Addendum 3  
TFM-028-26 – TA-511-25 ACADEMIC TUNNELS RE-WATERPROOFING CP-2 (Paton College Tunnels)

- .2 The Date of the Addendum is Friday, April 24, 2026

PROJECT NAME:  
**ACADEMIC TUNNELS  
 RE-WATERPROOFING (PATON  
 COLLEGE TUNNELS) CP-2**  
 Project #: TA-511-25

DRAWING TITLE:  
**PATON COLLEGE TUNNELS  
 DEMOLITION SITE PLANS**

NEW TO EXISTING WATERPROOFING MEMBRANE DETAIL  
SCALE: 1:5

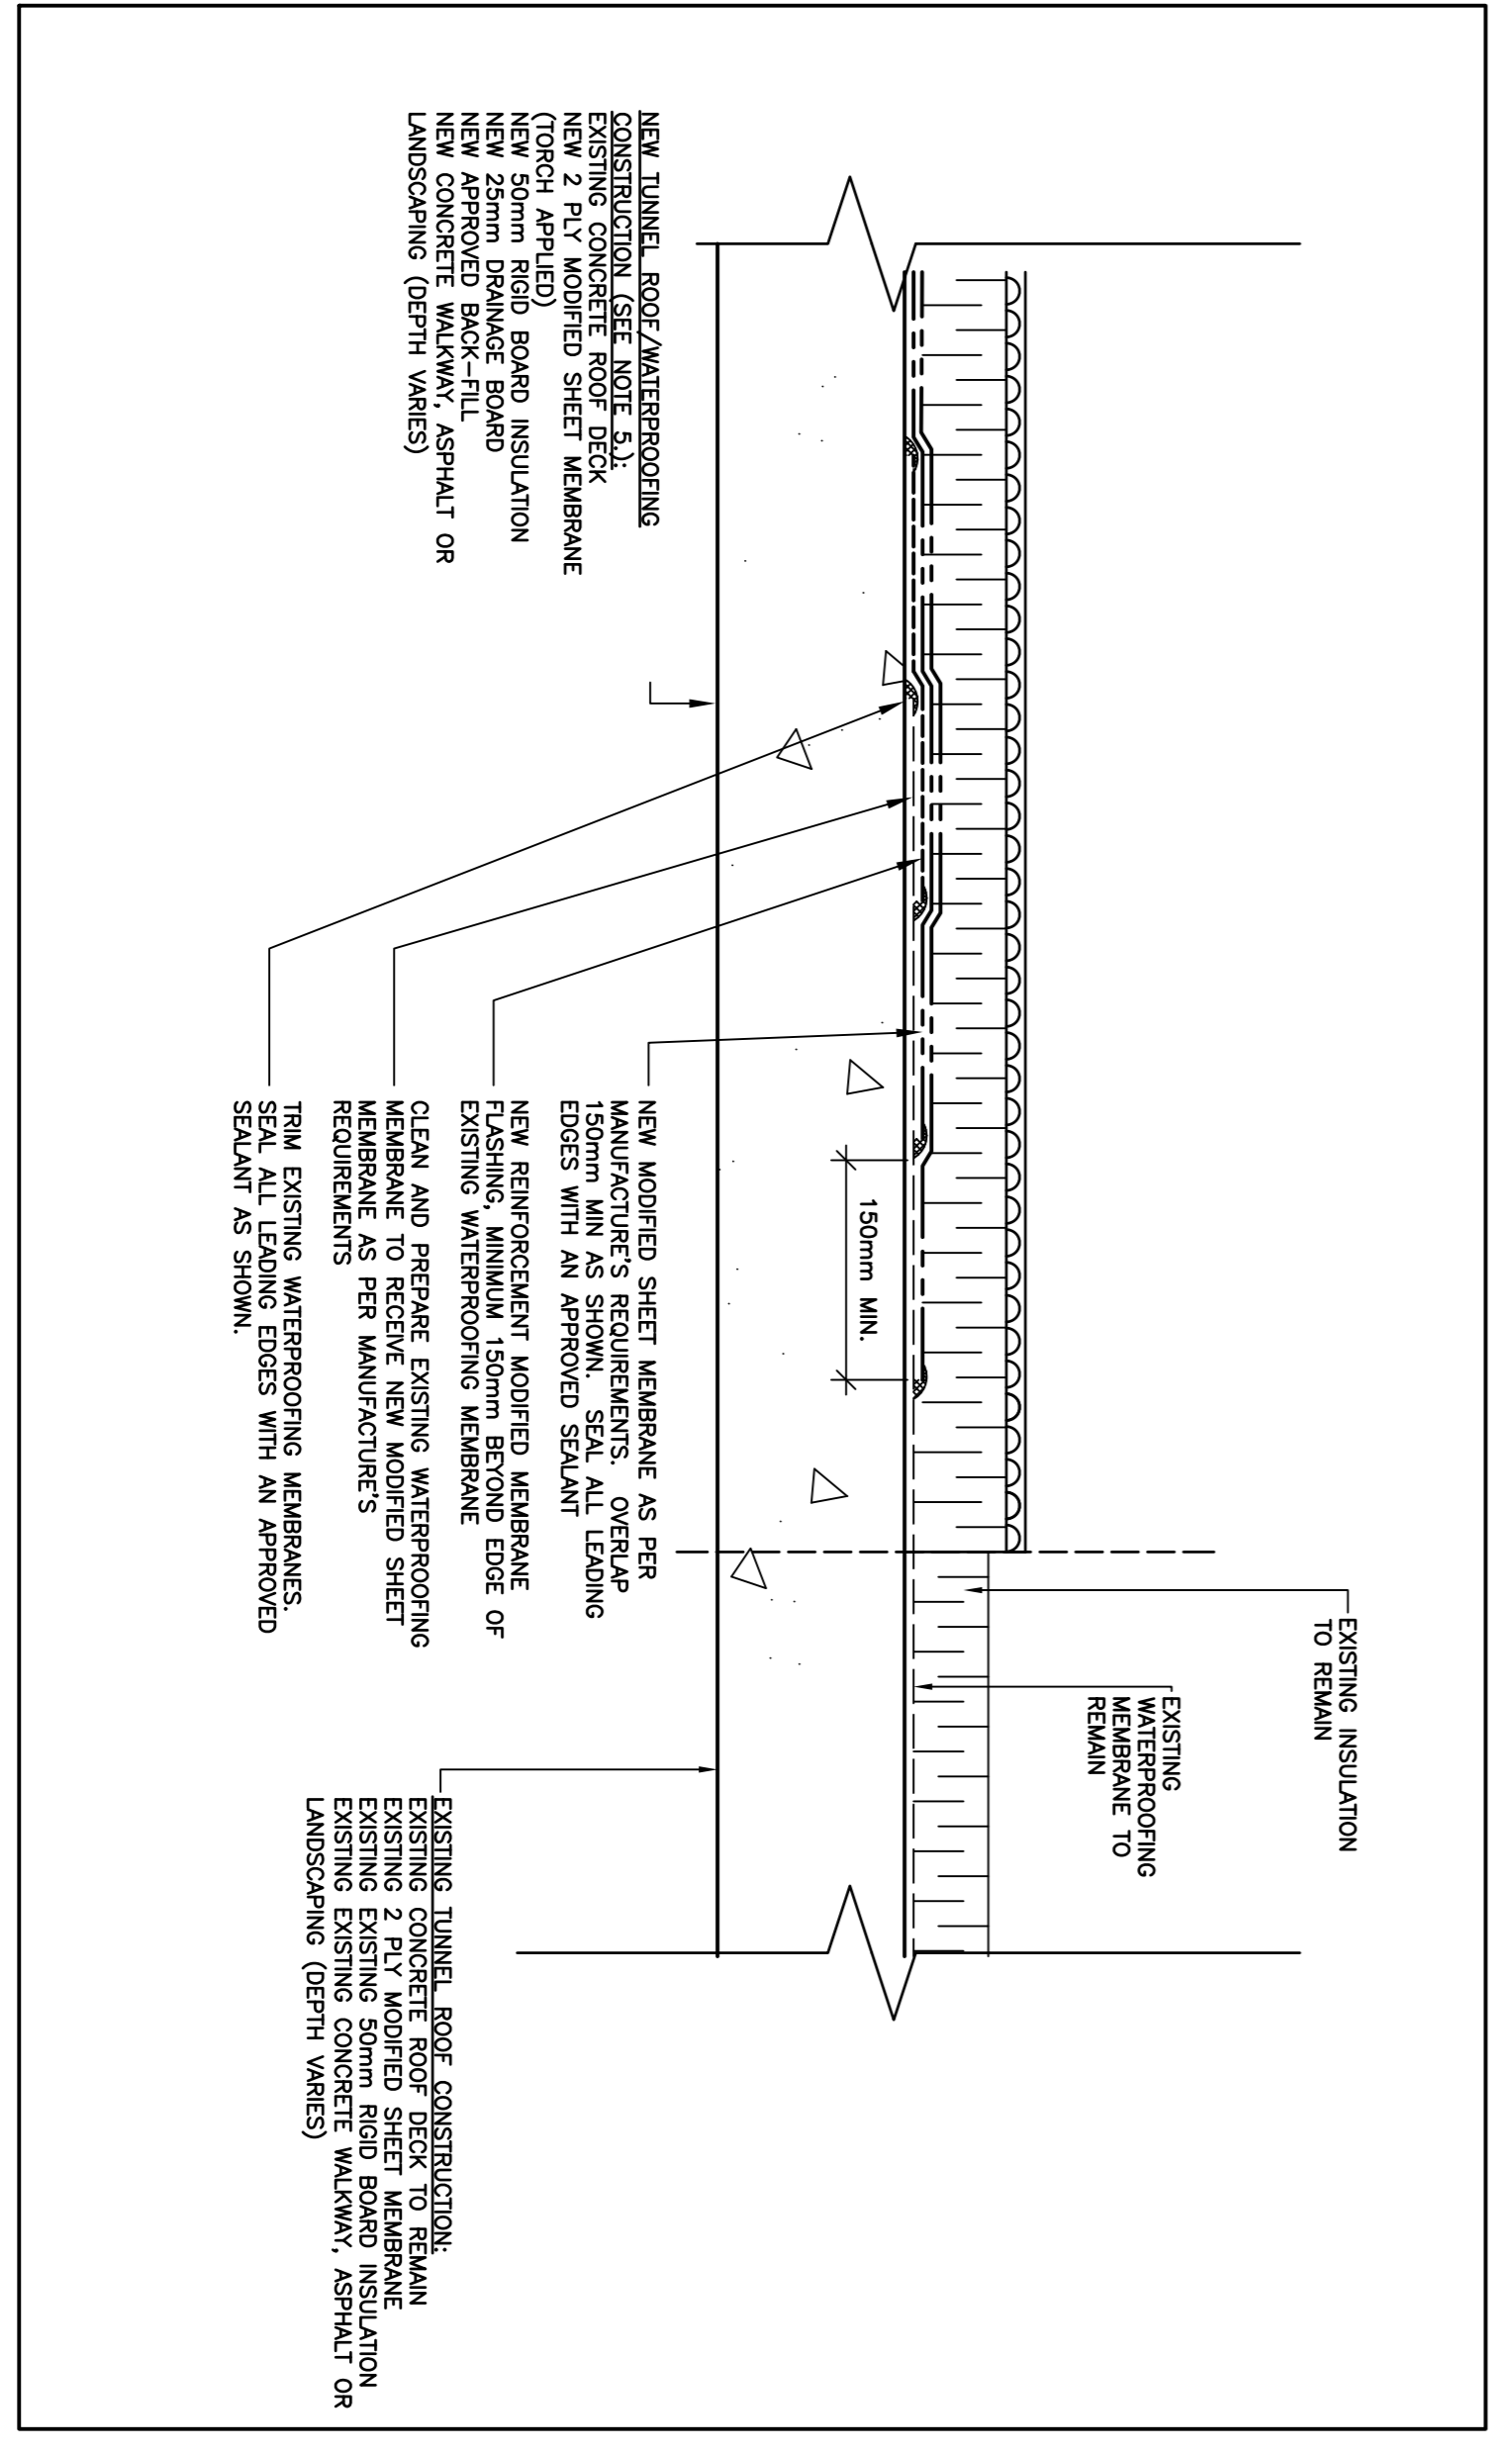
6. **Question:** Details 3/C-2.0 and 5/C-2.0 show that 2.0% tapered insulation should be installed at the roof/wall intersections and at the control/cold joints. However, the extents of where tapered insulation is required is unclear. Would it be possible to issue a revised drawing or other means of clarification to indicate the tapered insulation areas?

**Answer:** The note in question was removed in Addendum #1

DESIGNED:	S.C	DRAWN:	S.C
REVIEWED:	J.A	APPROVED:	E.H
SCALE:	AS SHOWN	DATE:	APRIL, 2026
PROJECT No.	TA-511-25	DRAWING No.	C-2.1

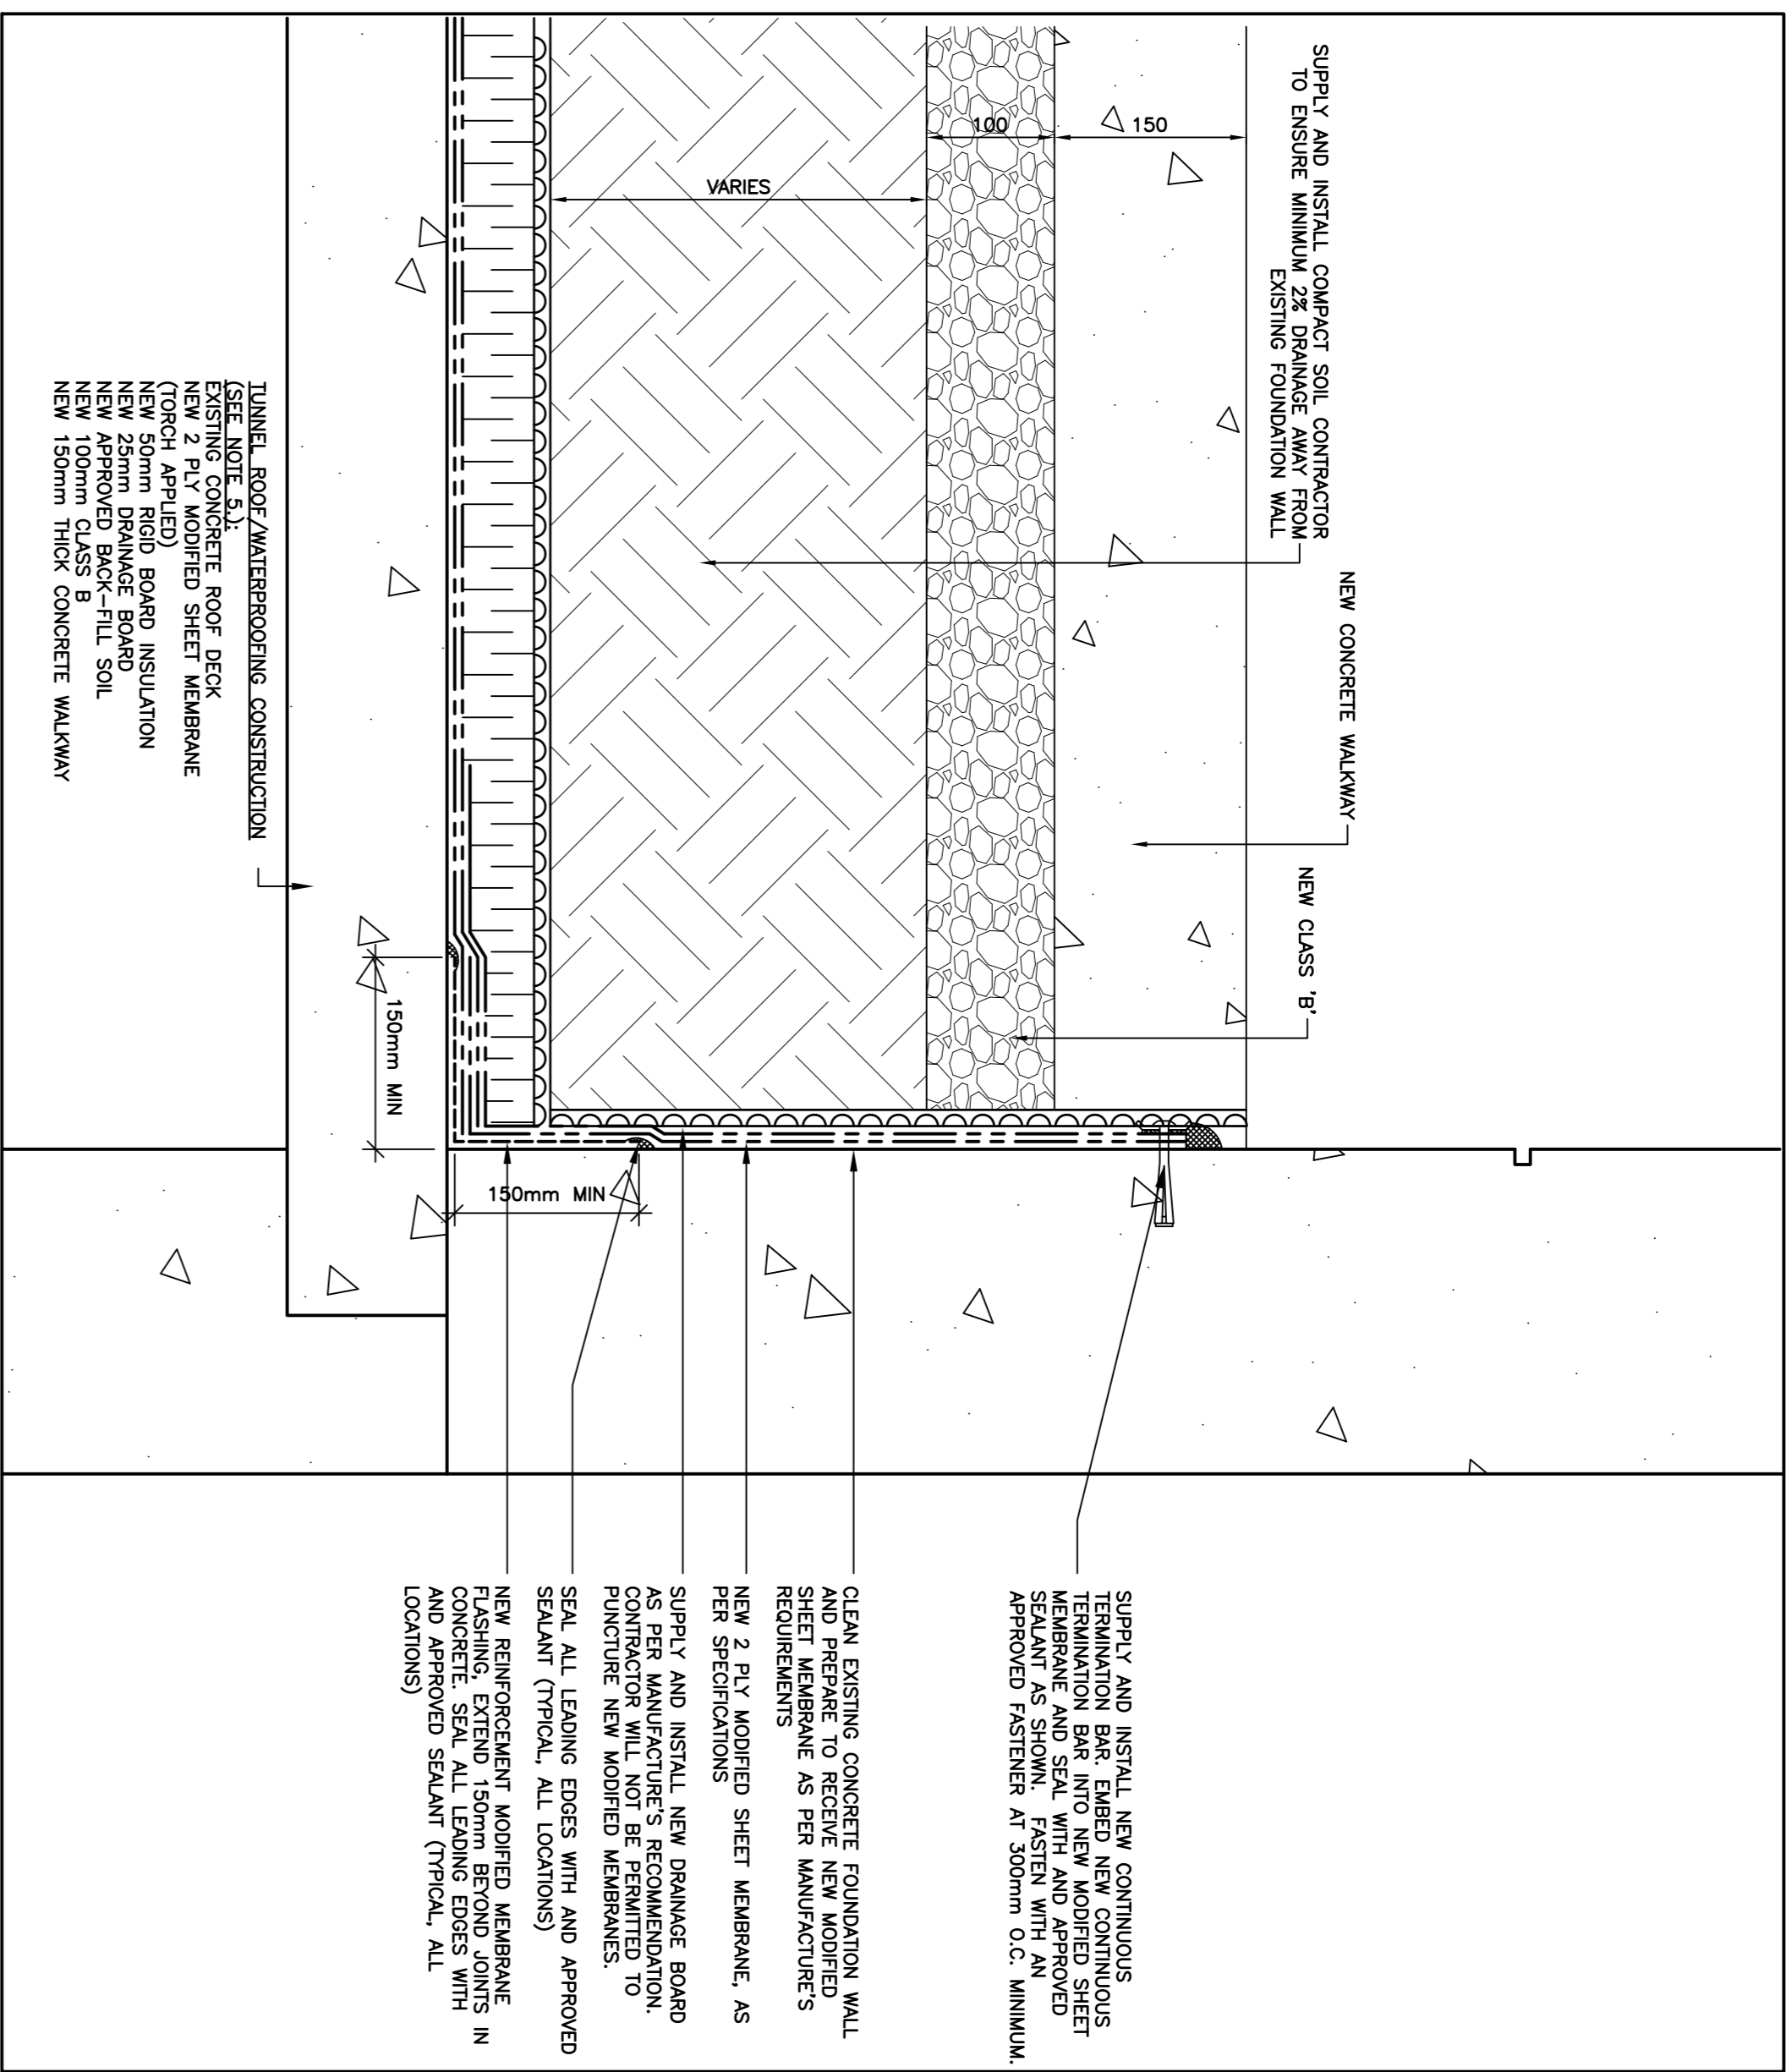
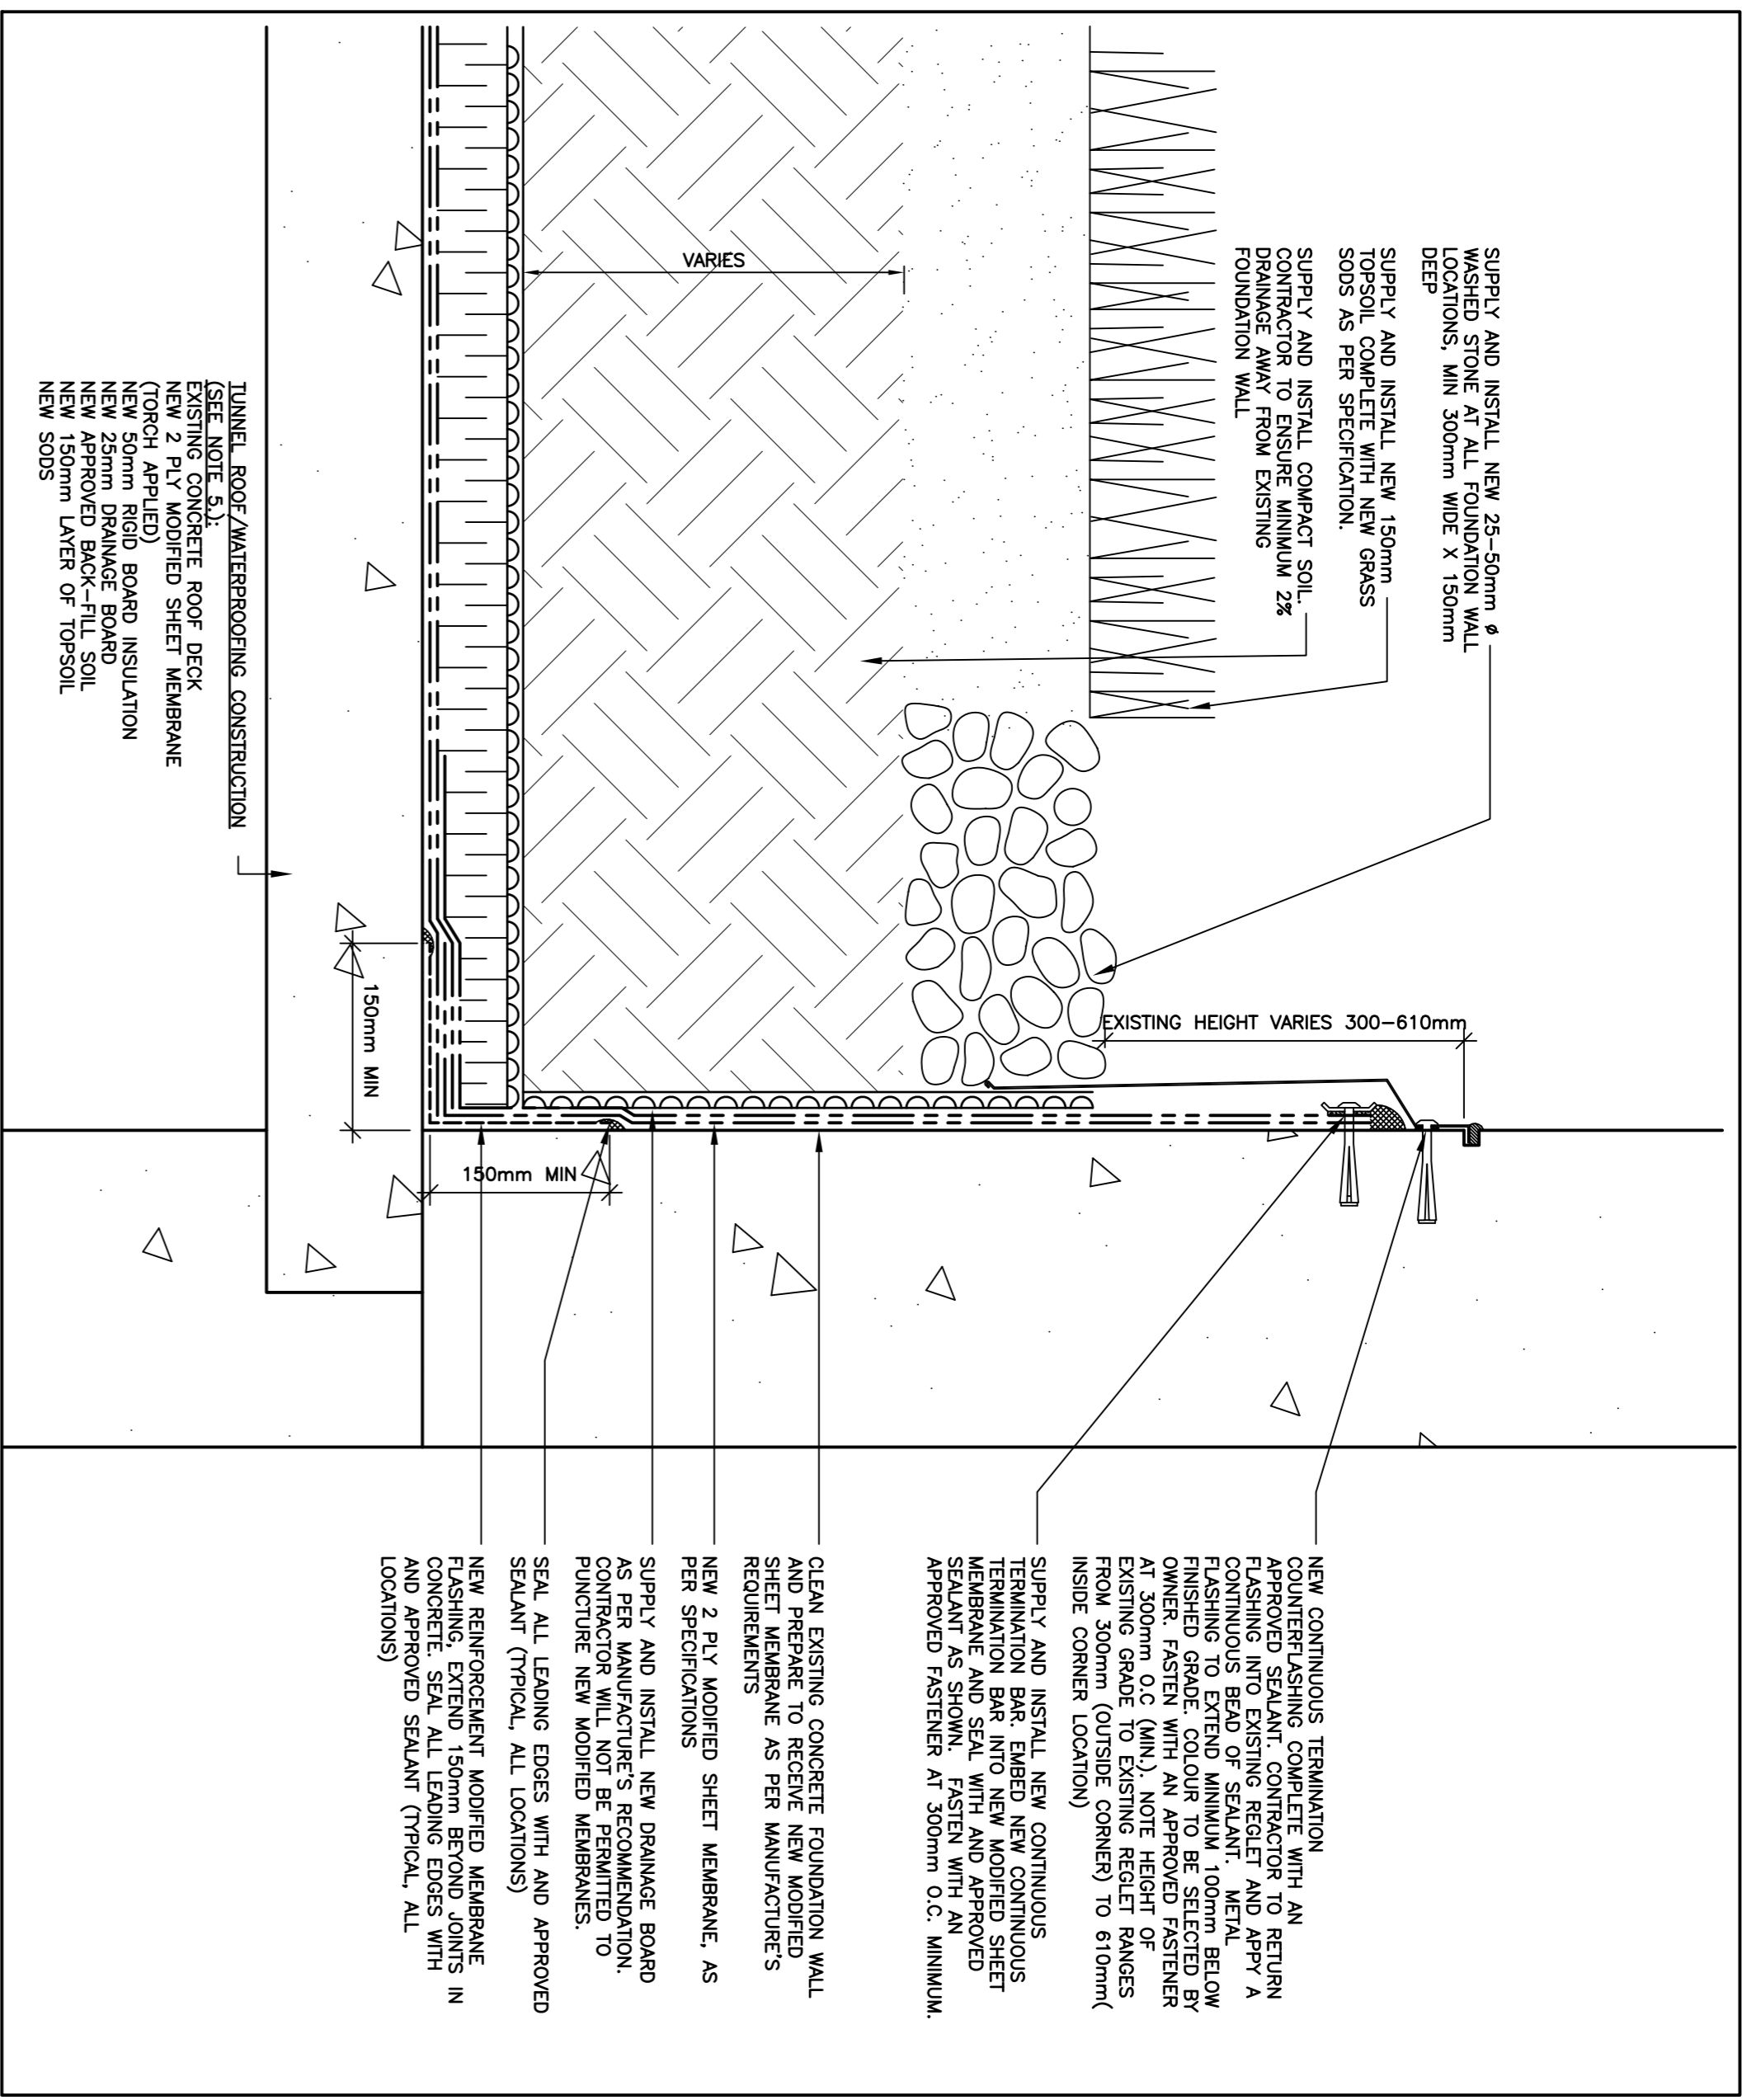
9. **Question:** For the existing U/G utilities tunnel above the academic tunnel, is this utilities tunnel rested upon the tunnel to be rewaterproofed, or does the utility tunnel need to be

supported during construction? If the utility tunnel is resting upon the tunnel to be rewaterproofed, how does this change the waterproofing detail?

**Answer:** The contractor is not expected to waterproof the full utility tunnel. The contractor is expected to tie the waterproofing system into the wall of the utility tunnel. Please refer to Detail 1 and Drawing C-2.1 for an illustration of the system tie-in.
